**Re: Building Code of Australia 2022 – Assessment Report
29 Grey Street Clarence Town NSW 2321 - Retail and Residential Development**

BUILDING CODE OF AUSTRALIA 2022

ASSESSMENT REPORT:

PROPOSED BAR, DINING AND FUNCTION CENTRE

FIGURE 21 THRESHOLD RAMP

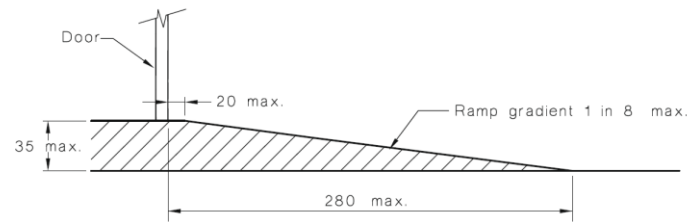
- Note: That changes in level are not permitted to exceed 35mm between internal floor and external ground at door thresholds. Level transitions are preferred. Details of the proposed transition between outside and inside entry doors to be provided for assessment – currently 50mm indicated.
